# CITY OF MILWAUKIE

## AGENDA

- 5.1 Summary: Ledding Library Reconstruction  
Applicant/Owner: Hacker Architects/City of Milwaukie  
Address: 10660 SE 21<sup>st</sup> Ave  
File(s): CSU-2018-002, NR-2018-001, DR-2018-001, P-2018-002  
Staff: Vera Kalias

**To:** Planning Commission

Figure 6. Harrison St elevation - window sill height above 30 inches

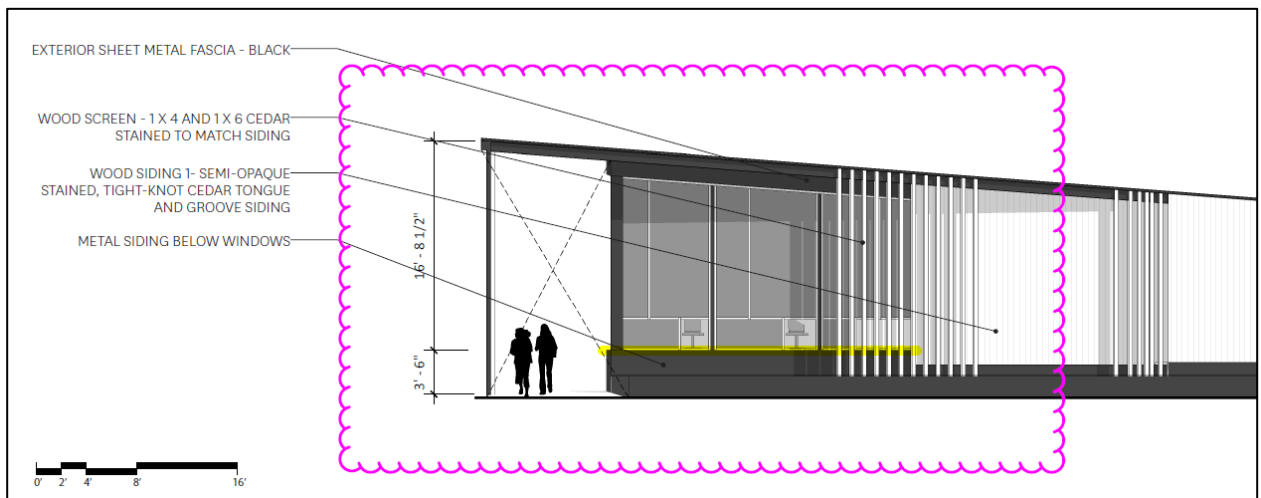
- Windows and Doors Standard: MMC 19.508.4.E.5.c states that the bottom edge of windows along pedestrian ways shall be constructed no more than 30 inches above the walkway surface. The proposed design complies in the majority of areas except where the finish floor height inside the building is higher than the walkway (for a maximum of 40 inches rather than 30 inches). The 40-inch disparity refers to the elevational difference between the interior finished floor and the abutting sidewalk (where a code maximum height sill at 30 inches above the sidewalk would be 10 inches below interior finished floor height). The disparity is a result of maximizing accessibility of the site and the building. See Figures 6 and 7 for the building sections where the window sill height exceeds 30 inches above the level of the walkway.

In certain areas, the window sills are 30 inches above the adjacent walkway (see Figures 6 and 7). This is to accommodate accessibility design as well as to accommodate interior power outlets and to provide a moderate level of privacy immediately adjacent to staff areas and workstations.

PHS Report Figure 3 (Existing Conditions)

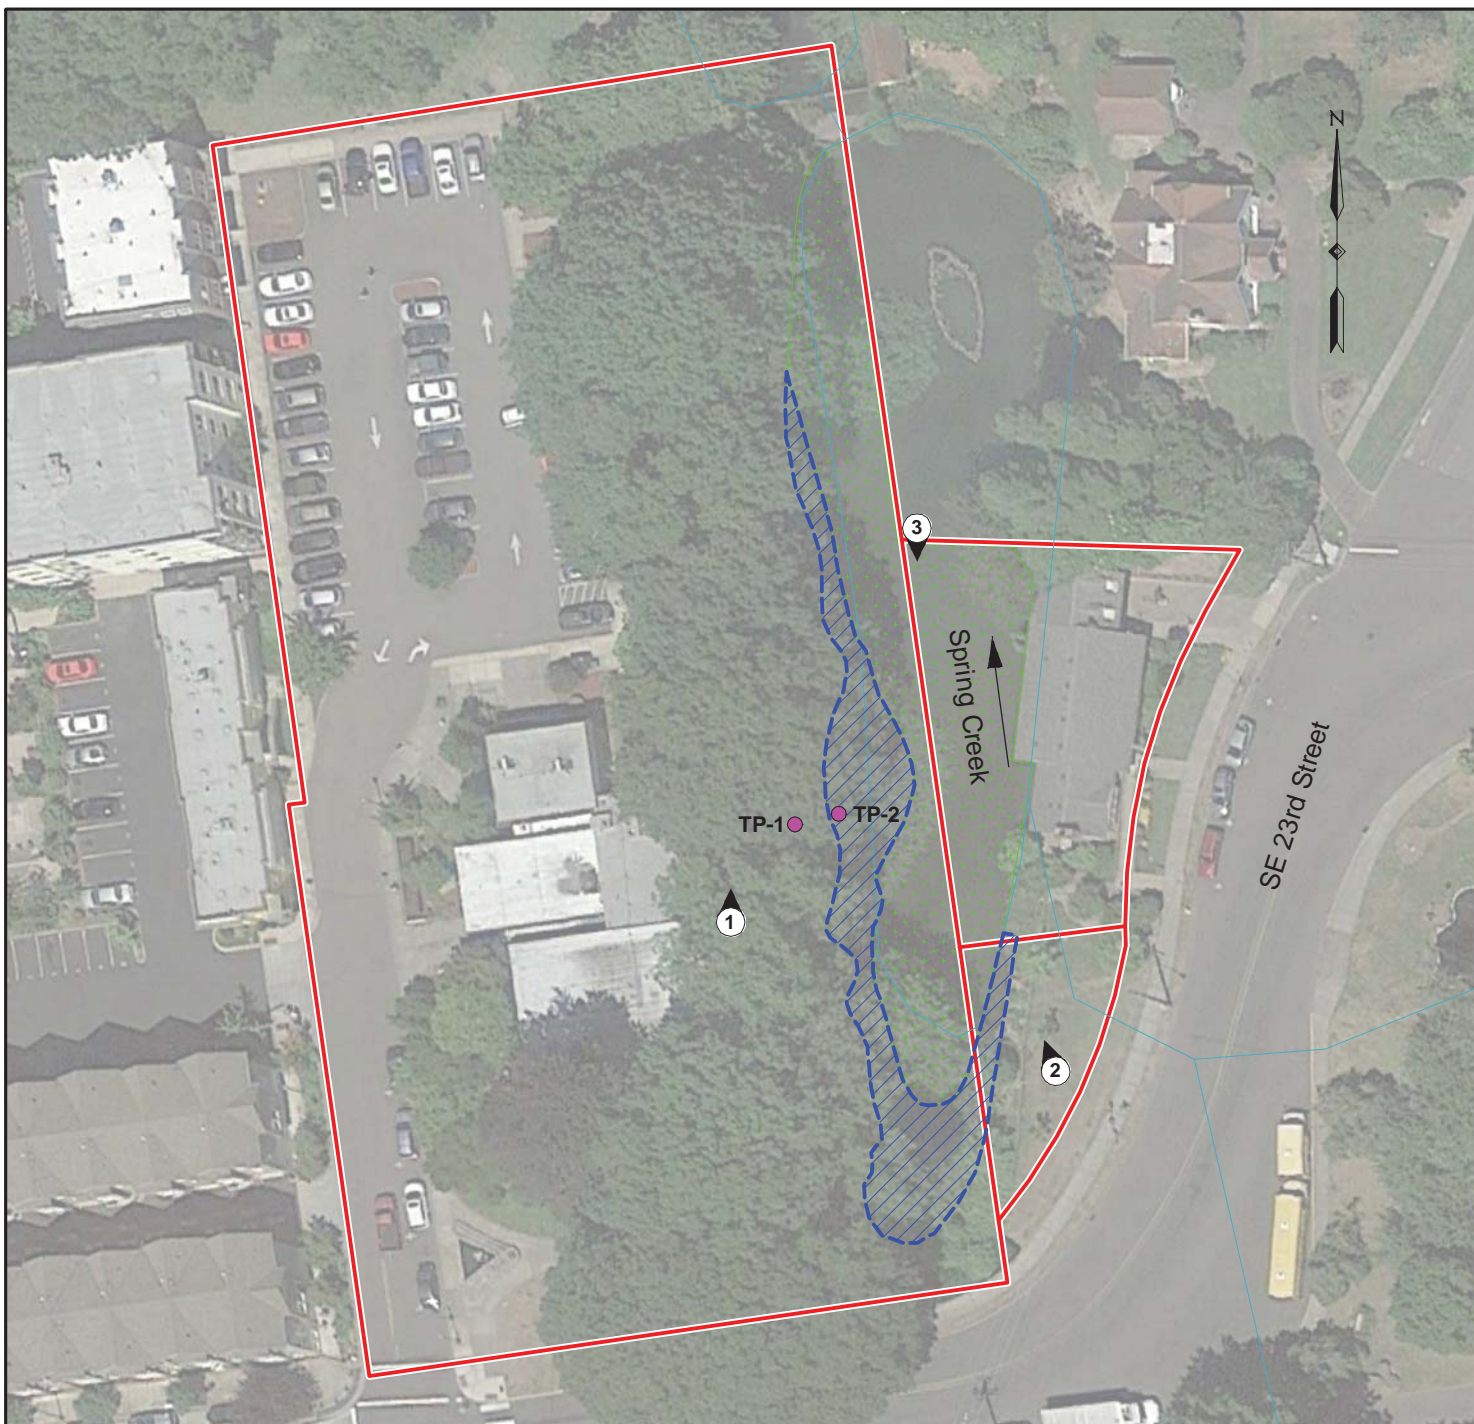
The PHS report Figure 3 (and other PHS report figures) does not distinguish Spring Creek from its adjacent wetland; the entire feature is simply labeled “Wetland” and there is no label on any PHS report figure that identifies Spring Creek. While some reference to Spring Creek on the figures would be helpful, the lumping of Spring Creek (below ordinary high water) with its adjacent wetland (above ordinary high water) into a single “Wetland” feature representing the Primary Protected Water feature is acceptable for establishing the adjacent vegetated corridor and thus the WQR regulated by MMC.

- PHS and Apex Wetland Boundary Difference: The “Wetland” boundary shown in PHS report Figure 3 does not appear to exactly match the wetland boundary shown in the Apex Wetland Delineation Report Figure 6, even though the PHS report text suggests that they are the same. Both figures are attached to this memorandum for reference.

It appears that the western “Wetland” boundary line shown in the PHS report figures generally follows the toe of a rock retaining wall that meanders in a north-south direction through the eastern portion of the site, while the Apex report Figure 6 shows a more complex boundary that likely differentiates wetland and non-wetland areas below the rock retaining wall. Also, the Apex report does not show a stream/wetland boundary extending beyond (north of) the asphalt-path crossing of the water feature on the northern portion of the site, while the PHS report figures show the wetland/stream extending through that area and encompassing the asphalt path.

- Vegetation Inventory: Tables 1, 2, and 3 of the PHS report list plant species and percent cover from three sample points in the vegetated corridor. The sample point locations are not identified on the report's Figure 3 (they should be), but the species noted in the report tables and described elsewhere in the report text are generally consistent with vegetation conditions as ESA staff observed during our February 23 site visit. ESA noted that many of the young native trees in the understory of the corridor, including a number of western redcedar, appear to have been planted.

Additional revisions to the figures have also been provided (attached). Figure 3 has been updated to show the three vegetation sample point locations. The sample point locations correspond to the vegetation inventory documented in the Natural Resource Review.
